Central Valley Regional Water Quality Control Board

9 April 2019

ORDER AMENDING CLEAN WATER ACT SECTION 401 TECHNICALLY CONDITIONED WATER QUALITY CERTIFICATION; DEPARTMENT OF WATER RESOURCES, COLLECTING CANAL BRIDGES CC-2 AND CC-4 REPLACEMENT AND REPAIR PROJECT (WDID#5A51CR00100A1), SUTTER COUNTY

The Certification is amended as shown in underline/strikeout format in Attachment A.

Figure 2: CC-2 Site Impacts

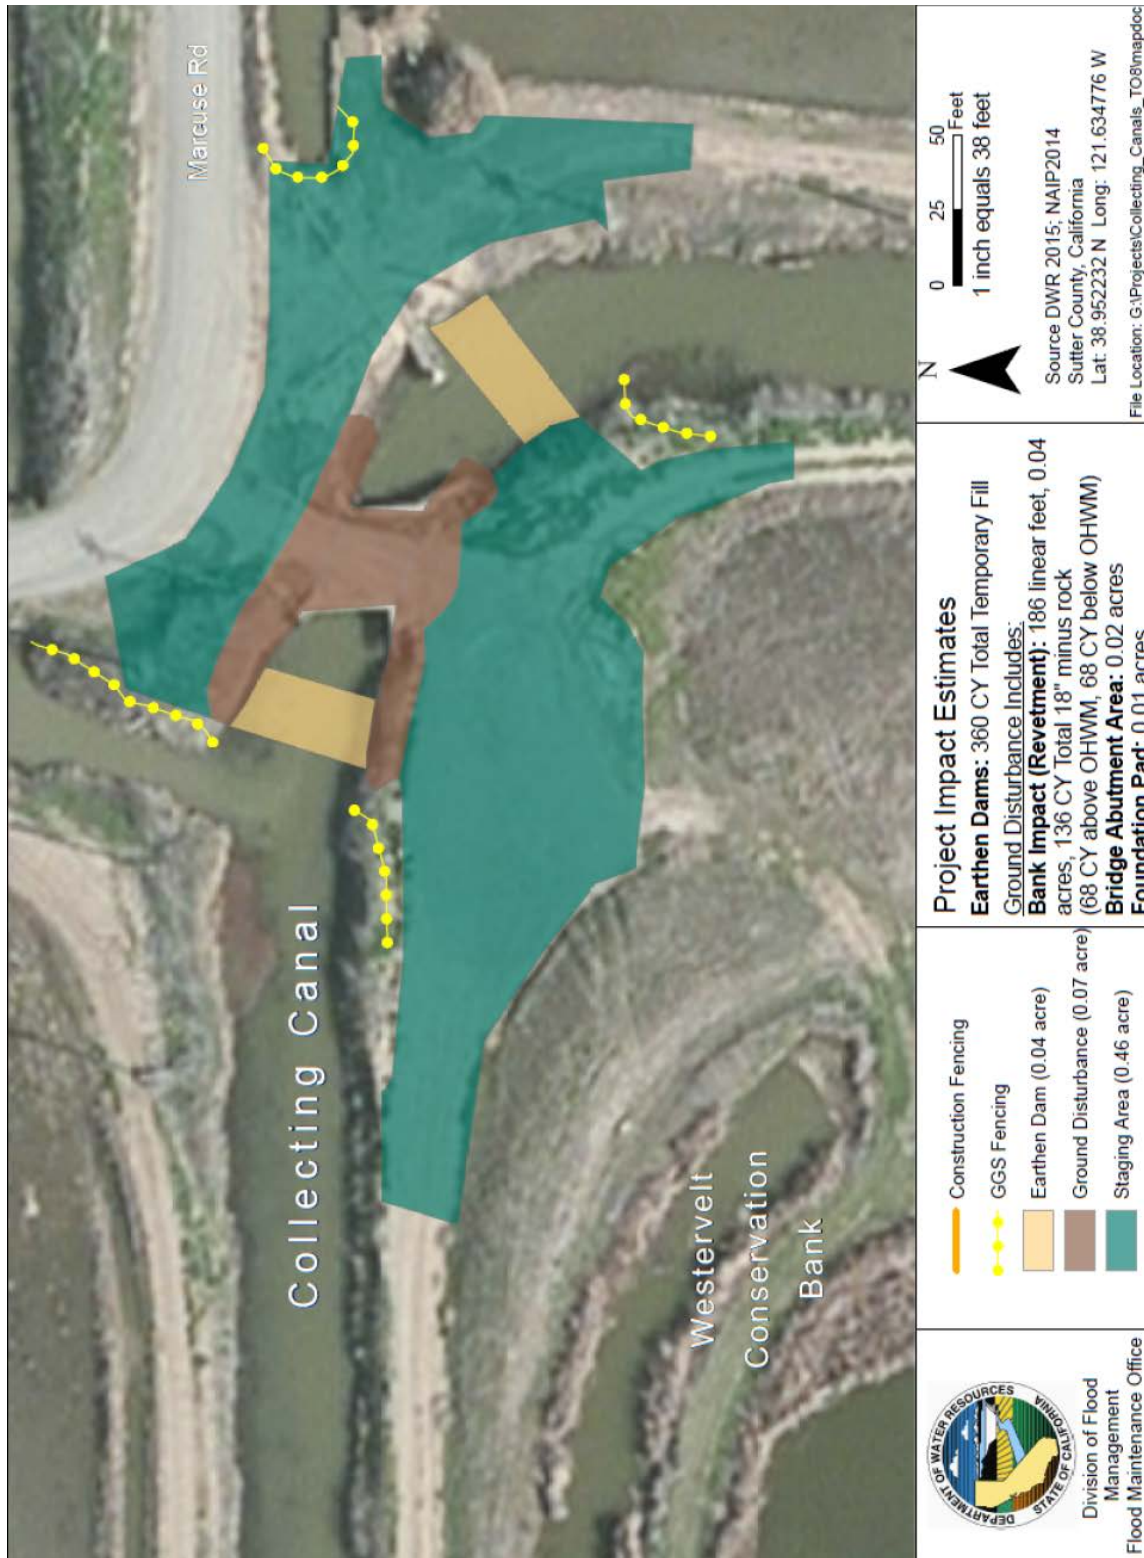
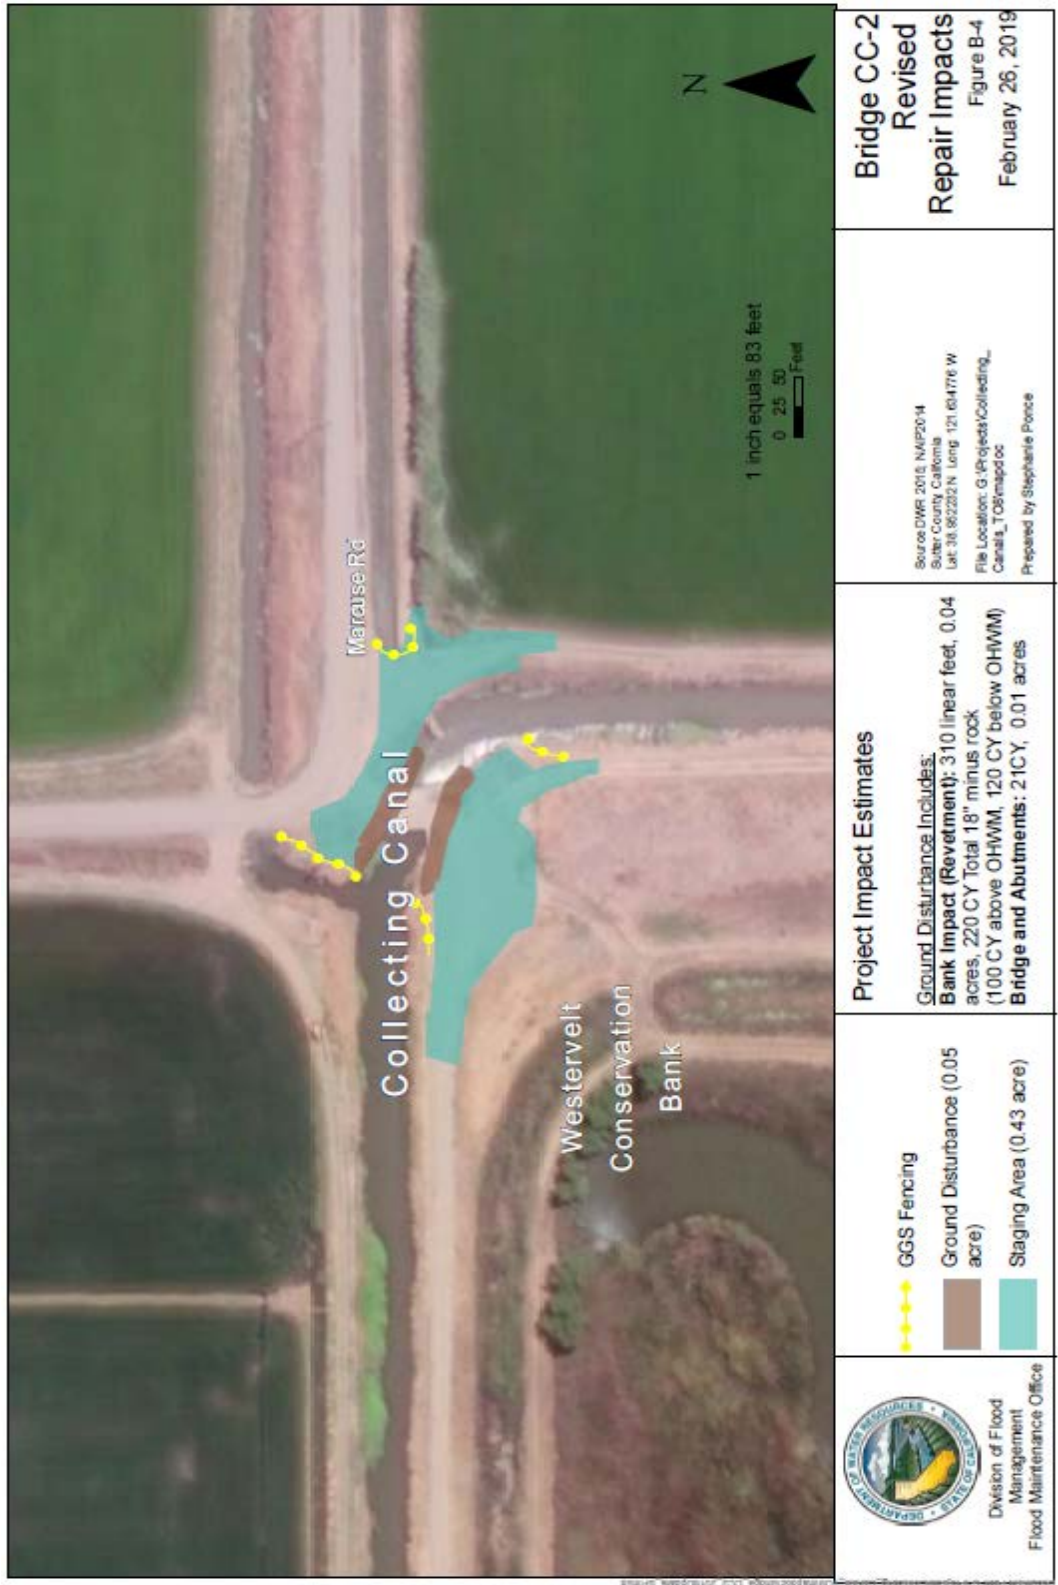
The Department of Water Resources is requesting an amendment to update the Project description and extend the expiration date. The initial structural evaluations of each bridge were performed in 2014 and noted severely deteriorated conditions of the timber members due to dry-rot and lack of proper foundation support for both bridges. A 2018 evaluation identified additional bridge deterioration that resulted in the decision to fully replace Bridge CC-4 instead of repairing it. In addition, Bridge CC-2 was re-designed to be a single-span bridge.

Replacement activities at CC-2 consist of ~~dewatering the canal~~, demolition and removal of the existing bridge, foundation pad construction and box culvert installation, and placement of rip rap. ~~Two earthen cofferdams will be constructed as shown in Figure 2 to facilitate dewatering. Flow will be diverted by pump around the Project area. Following dewatering, approximately~~ Approximately 500 cubic yards of soil will be removed to facilitate bridge removal. Soil will be stockpiled on the staging area for reuse at the Project site. Timber and concrete from the existing bridge will be removed by crane and disposed of at an appropriate disposal site. A foundation pad will be constructed by excavating approximately 2 feet of the canal bed and placing a 37 cubic yard layer of aggregate base and sand bedding in the excavation. A crane will set 6 precast concrete box culverts in place to form a roadway with precast concrete headwalls installed around each end of the box culvert. Bridge CC-2 will be replaced with a single span concrete deck with supporting steel I-beams set into concrete abutments on each end. The lengths of the bridge will be 40-feet long and 20-feet wide. The abutments will be 2-foot wide, 20-feet long, and 4-feet deep. Following placement, the banks will be backfilled with on-site soil and compacted. Approximately 68 cubic yards of rip rap will be placed adjacent to the box culvert to tie into existing canal banks 220 cubic yards of 18-inch minus revetment will be placed immediately upstream and downstream, 120 cubic yards below the ordinary high-water mark (OHWM) and 100 cubic yards above the OHWM. Construction is anticipated for a 5-week duration.

Figure 3: CC-4 Site Impacts

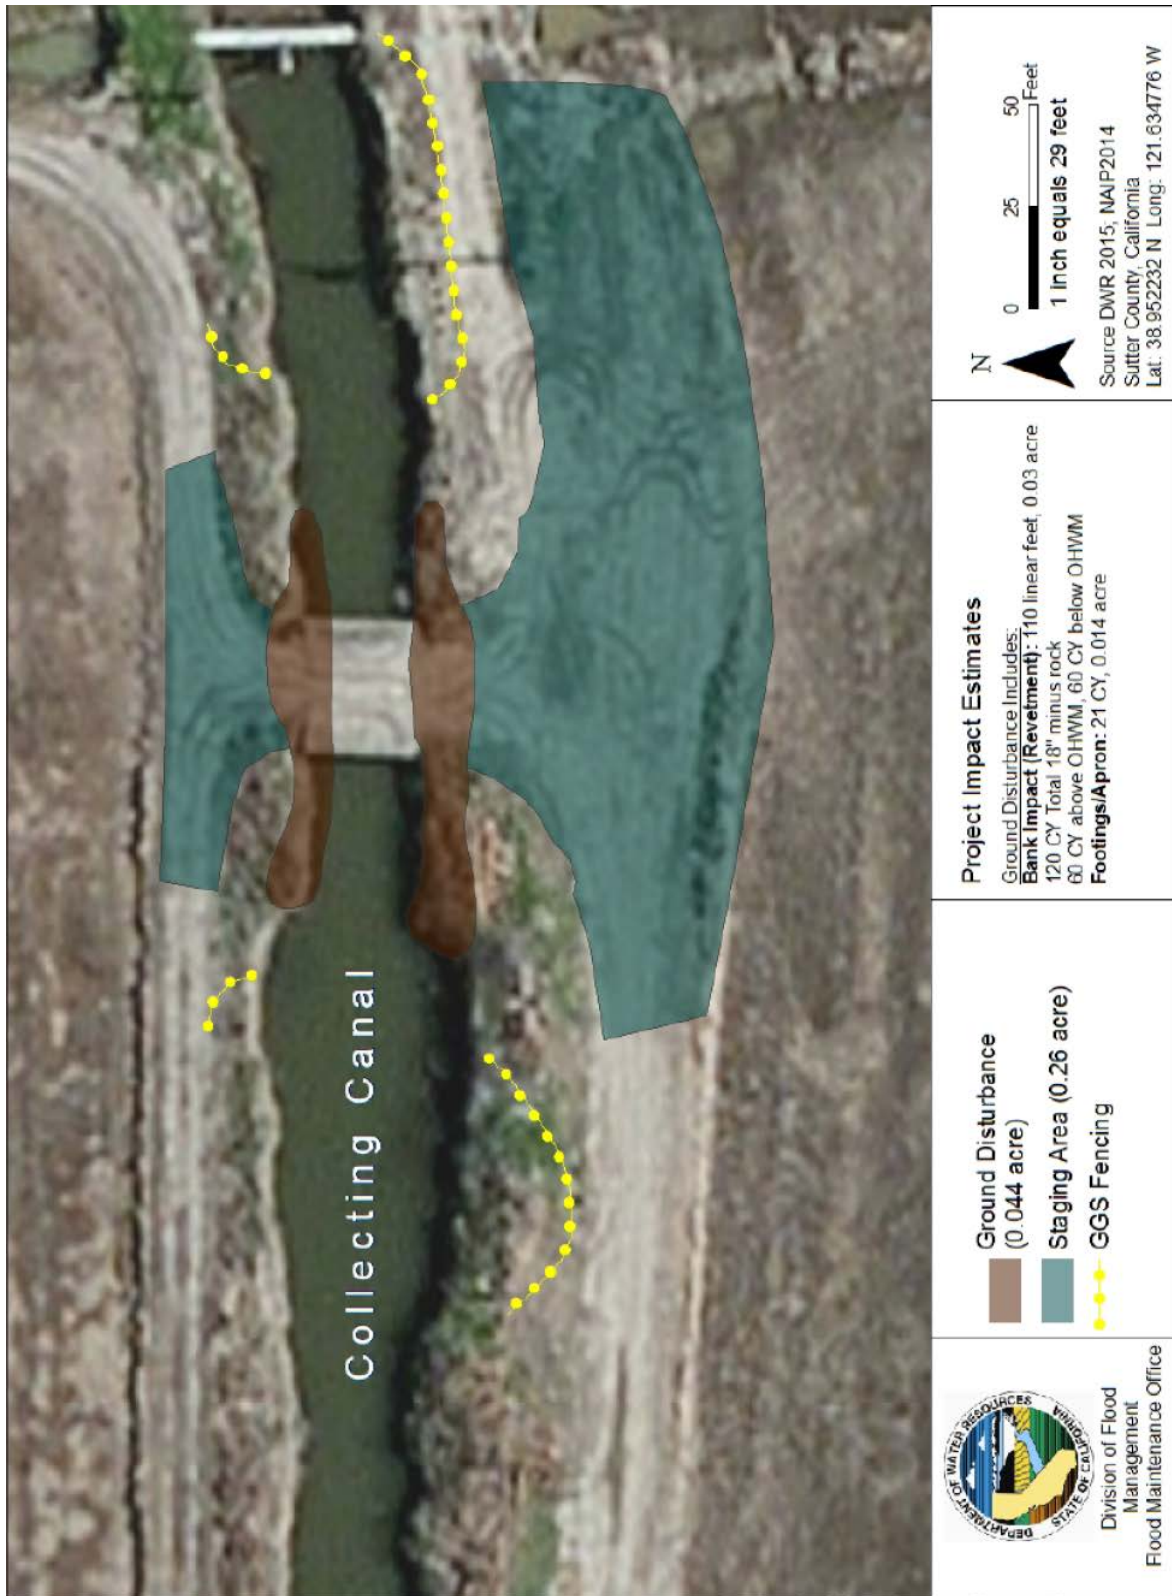
Repair activities at CC-4 consist of excavating the existing bridge aprons and constructing new concrete footings on each side of the bridge in the upland area, installing new concrete bridge aprons and timber bridge deck extensions on each side of the bridge in the upland area, and placement of rip rap along the canal banks. The repaired bridge will have the same footprint. No dewatering will occur at CC-4. Following construction of the new bridge footings, concrete approach apron, and timber bridge deck extension, approximately 60 cubic yards of rip rap will be placed adjacent to the bridge to tie in existing canal banks.

The designs for the replacement of bridge CC-4 will be identical to the CC-2 replacement bridge, a 20-foot wide deck 40-feet long supported by steel I-beams sitting on concrete abutments 20-feet long, 2-feet wide and 4-feet deep. The excavated material will be used on-site or spread onto the existing access road. New revetment (approximately 120 cubic yards of 18-inch minus revetment: 60 cubic yards below the OHWM and 60 cubic yards above) will
